Tennessee Valley Authority, 1101 Market Street, Chattanooga, Tennessee 37402-2801

TVA NUCLEAR (TVAN) RADIOLOGICAL EMERGENCY PLAN (REP) REVISION 60

This letter references our letter to you dated June 11, 2001 on the above subject. The enclosed information is being submitted for editorial purposes.

DOCUMENT RELEASE AND FILING INSTRUCTIONS

FIGURE B-4
OPERATIONS SUPPORT CENTER
Plant Office Building Elevation

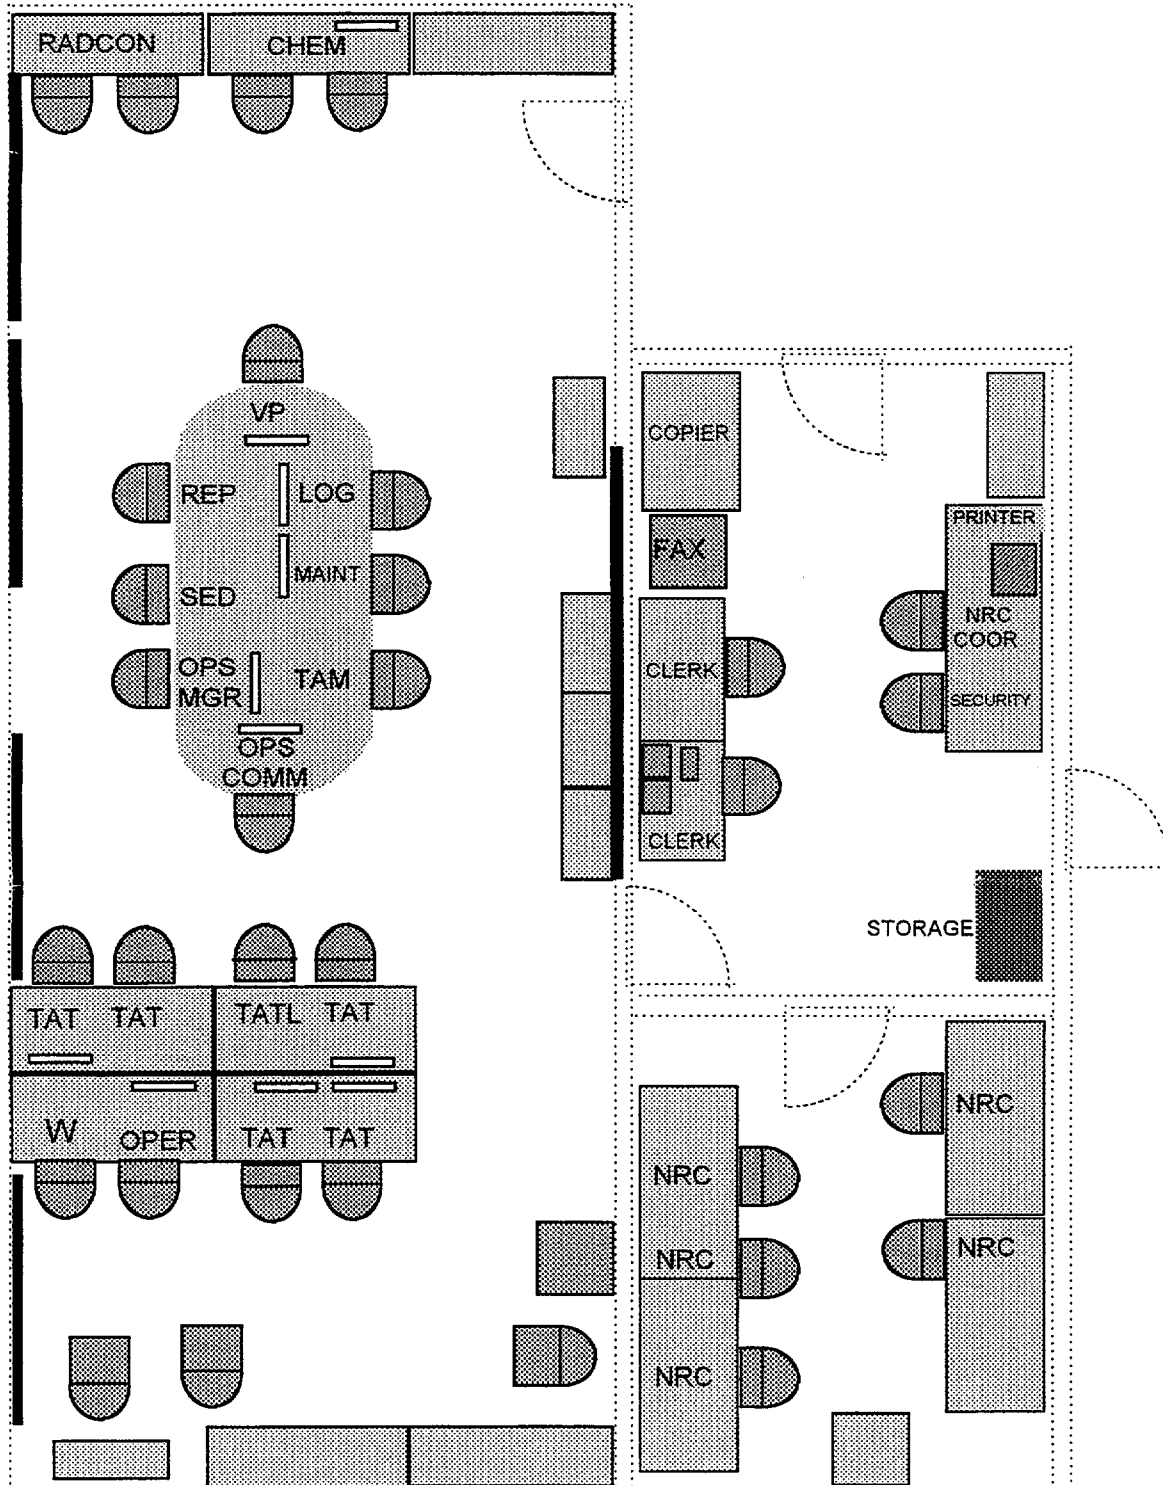
*PAGE 190 REISSUED
 TO CORRECT TYPO-
 TWO CHARTS OVERLAPPED.
 PAGE 189 REISSUED
 FOR DUPLEXING PURPOSES.*
